TURKEY POINT PLANT UNIT NO. 3

AMENDMENT TO FACILITY OPERATING LICENSE

Amendment No. 95
License No. DPR-31

DOCKET NOS. 50-250 AND 50-251

FIGURE 3.1-1

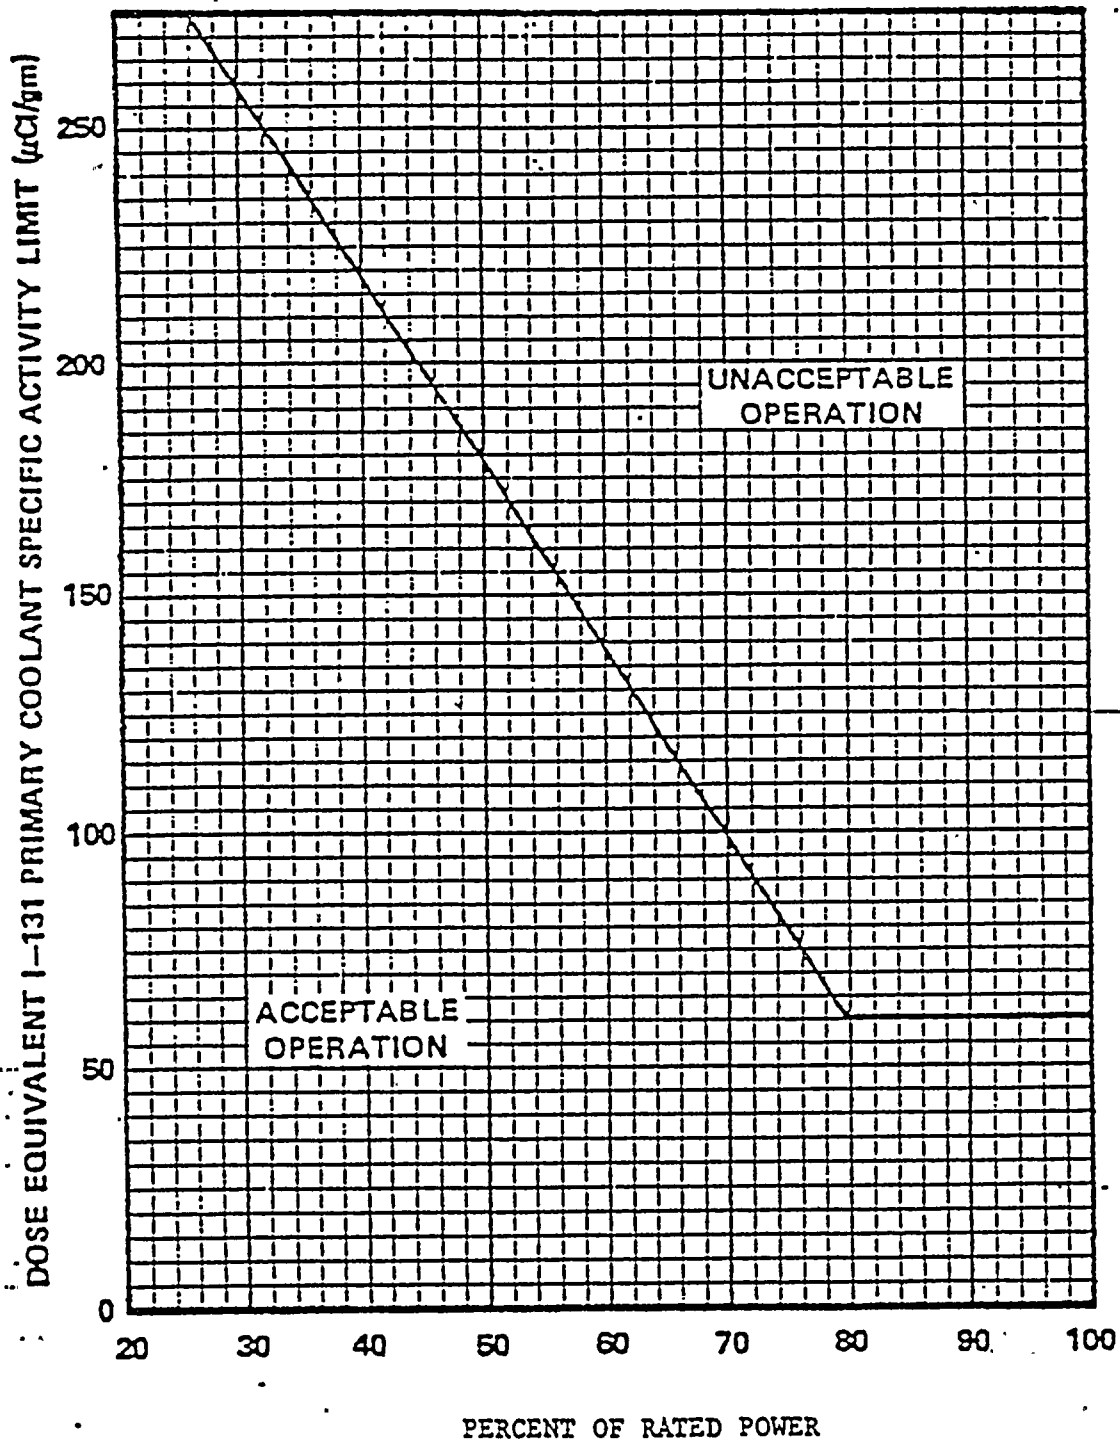
- 1. When the reactor is critical or average reactor coolant temperature is greater than 500 F:
 - a. With the specific activity of the primary coolant greater than 1.0 microcurie per gram DOSE EQUIVALENT I-131 but within the allowable limit (below and to the left of the line) shown on Figure 3.1-1, operation may continue for up to 48 hours provided that the cumulative operating time under these circumstances does not exceed 800 hours in any consecutive 12 month period. With the total cumulative operating time at a primary coolant specific activity greater than 1.0 microcurie per gram DOSE EQUIVALENT I-131 exceeding 500 hours in

- b. With the specific activity of the primary coolant greater than 1.0 microcurie per gram DOSE EQUIVALENT I-131 for more than 48 hours during one continuous time interval or exceeding the limit line shown on Figure 3.1-1, be in a SHUTDOWN condition with average reactor coolant temperature less than 500 F within 6 hours.
- c. With the specific activity of the primary coolant greater than $100/\bar{E}$ microcuries per gram, be in a SHUTDOWN condition with average reactor coolant temperature less than 500 F within 6 hours.
